BRADFORD NORTH

AN ADDITION TO WICHITA, SEDGWICK COUNTY, KANSAS

Re: 93-78 BRADFORD NORTH ADDITION (Final Plat)

CASE NUMBER: S/D 93-78 BRADFORD NORTH ADDITION

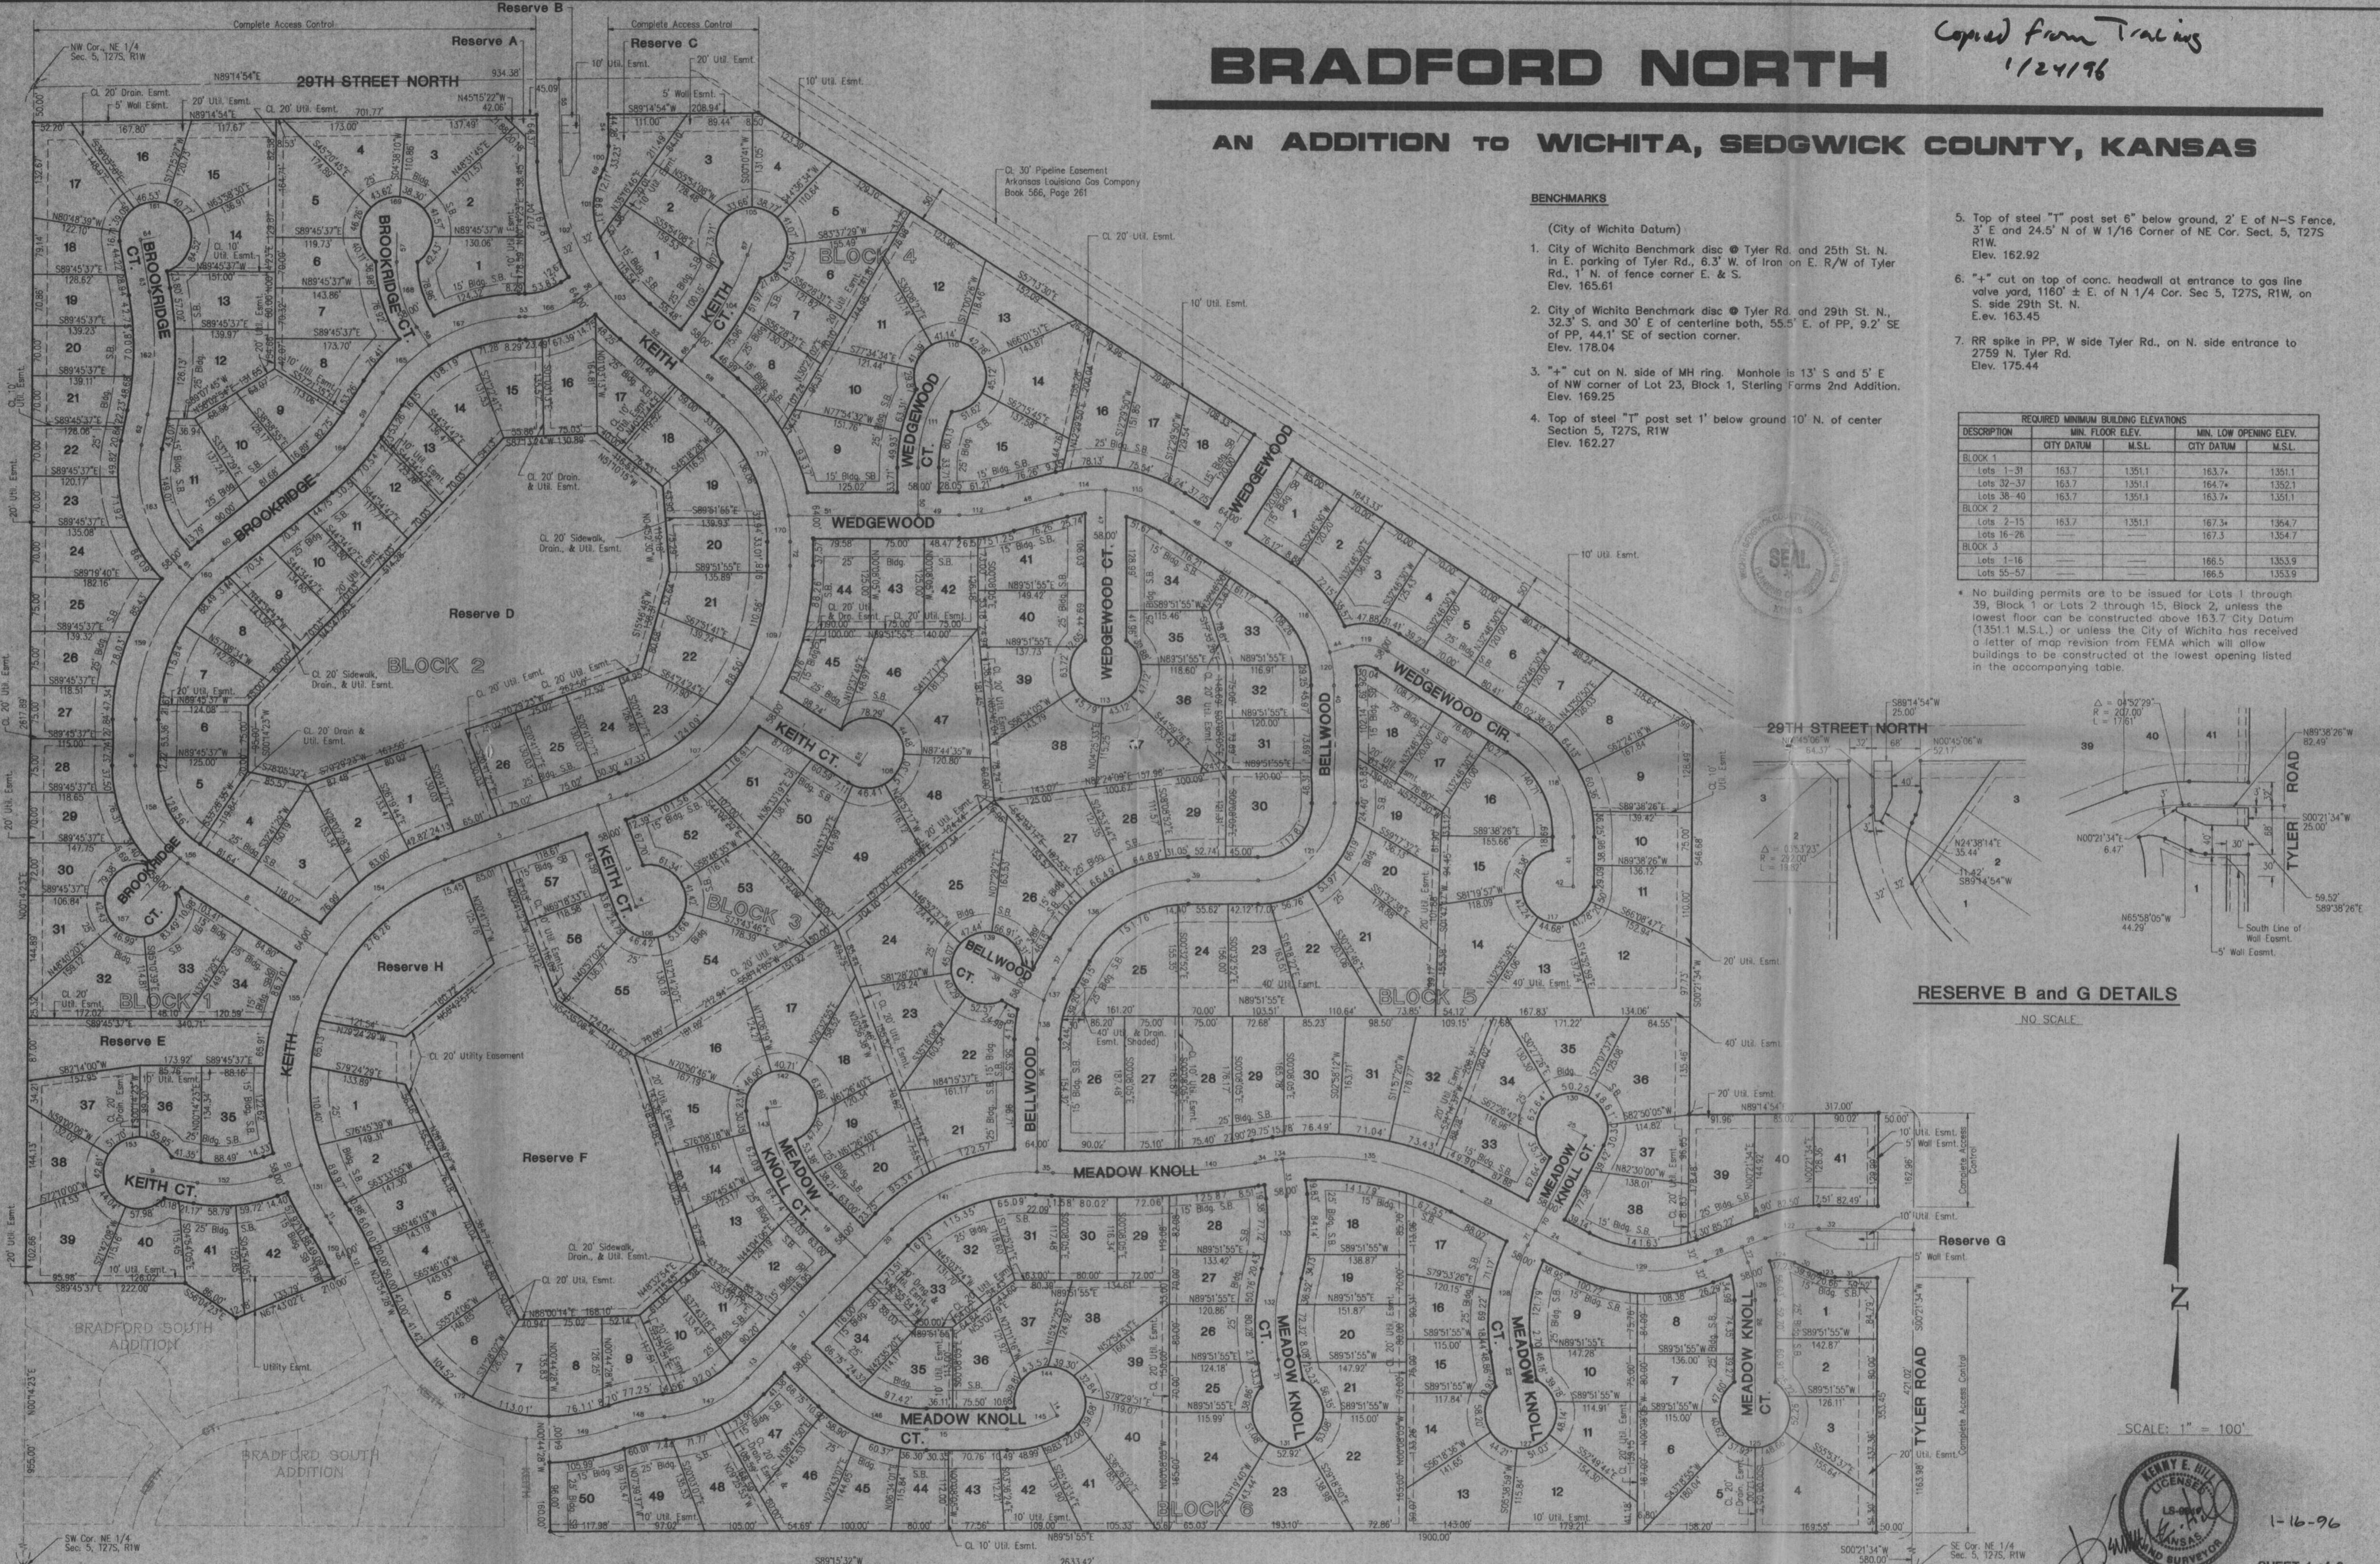
O. On the final plat tracing, as shown on the preliminary plat each separate, noncontiguous Reserve needs to be provided a separate letter designation. That is each of the Reserve areas now shown as a Reserve A or B shall be individually lettered. The plattor's text shall consequently also be revised to note each such Reserve and precisely note the uses to be

P. The plat's text shall also clearly note that utilities within the Reserves are confined to easements. As now written, all of the Reserve area, in addition to indicated easements could be used for utilities. In such a situation, no structures could be allowed in the Reserves since utility conflicts could be involved.

R. The plat's text shall also be amended to indicate the platting of the wall easement and that utilities may cross this easement.

S. On the final plat tracing, the following changes shall be made:

- The cul-de-sac serving Lots 34 thru 41, Block 1 shall be renamed Keith Ct.
- The cul-de-sac Wedgewood serving Lots 4 through 18, Block 5 shall be designated a Circle.
- The MAPC signature block shall be amended to indicate Susan Osborne-Howes as Chair(man).
- The MAPC approval date will most likely still occur this year and the noted date should therefore still be shown as 1995.
- The County Clerk's signature block shall be amended to indicate Susan E. Crockett-Spoon.
- The street segments where Keith is shown as meeting the Bradford South Addition shall use dashed lines to indicate where the street intersects that Addition. Solid lines are used to indicate private streets.

still need to off-site along Rte N.E. line
U. The final plat shall indicate the utility easements requested by K.G. & E. and Southwestern Bell which are indicated on the enclosed "marked" copy of the plat.

submitted a plan - also eliminate 3 lots to plat Res. for pool
Q. If the "recreation" facilities noted for one of the Reserves (b) is intended to include a swimming pool and associated facilities, the plat's text shall clearly state this and a site plan must be submitted to Planning for review and approval.
